TfNSW Reference: SYD17/01529/15

DPE Reference: SSD 8859

AMENDED PLANS FOR ELIZABETH DRIVE SUBDIVISION AT 1111-1141 ELIZABETH DRIVE, CECIL PARK

DA SITE ACCESS- OPTION 2

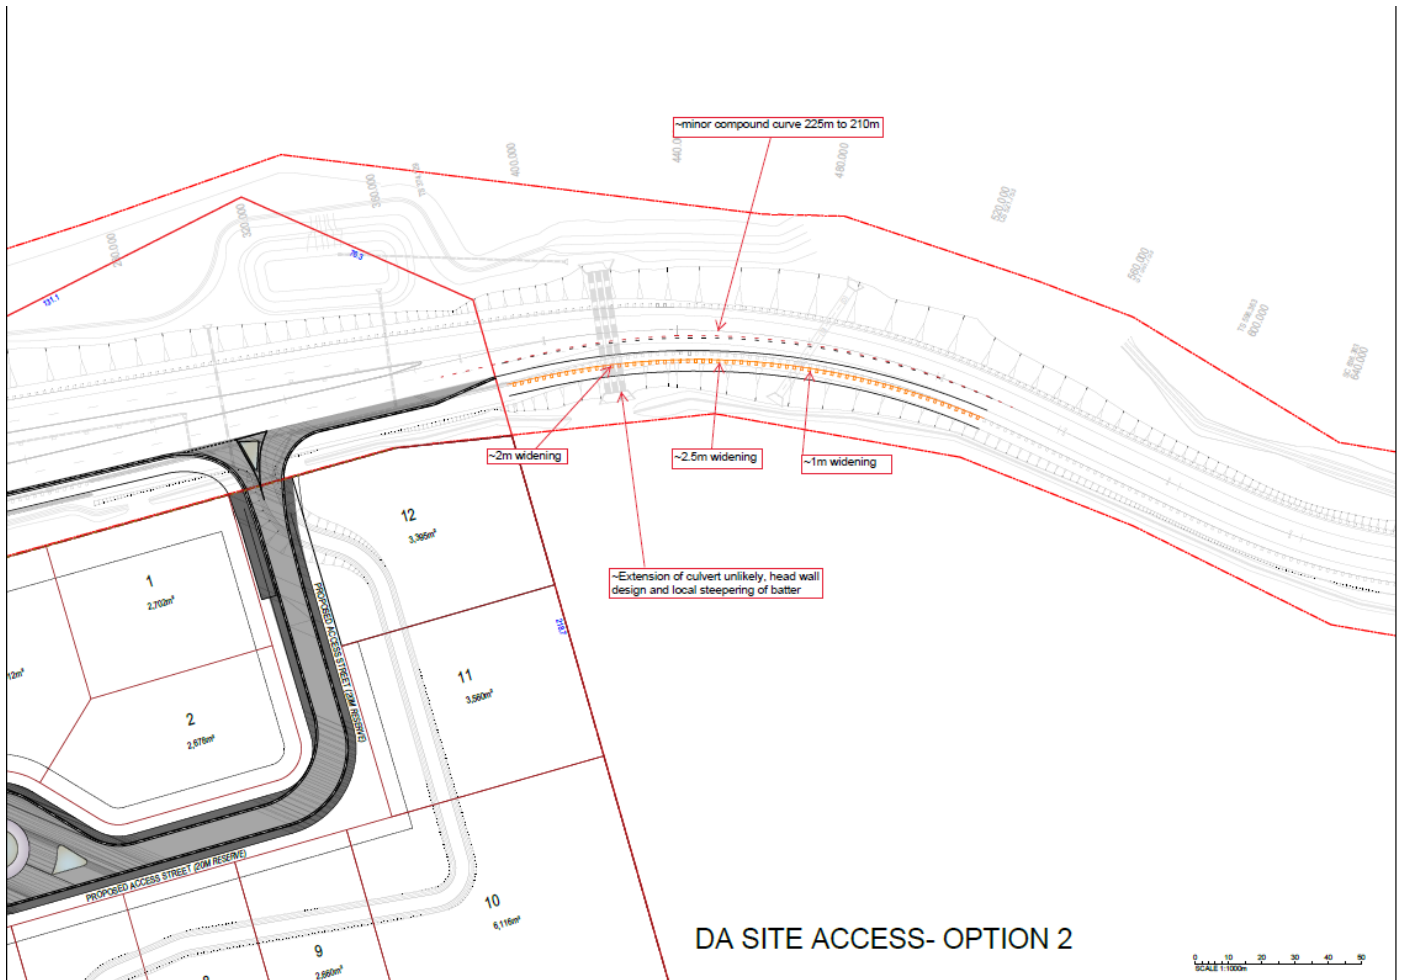
1. The proposed access arrangement necessitates redesign of future Wallgrove Road to ensure safe access and egress to/from the development site on Wallgrove Road.

The redesign works will include (but not limited to) line marking changes, minor widening of the proposed carriageway, localised steepening of the batters and may require an increase in pipe culvert lengths, in accordance with the attached sketch. The proposed access arrangement and the above required works (both design and construction) should be at full cost of the developer and no cost to TfNSW.

2. The proposed deceleration lane and the redesign works (described above) along future Wallgrove Road shall be designed to meet TfNSW requirements, and endorsed by a suitably qualified practitioner. The design requirements shall be in accordance with AUSTROADS and other Australian Codes of Practice. The certified copies of the civil design plans shall be submitted to TfNSW for consideration and approval prior to the release of the Construction Certificate by the Principal Certifying Authority and commencement of road works. Please send all documentation to development.sydney@transport.nsw.gov.au.
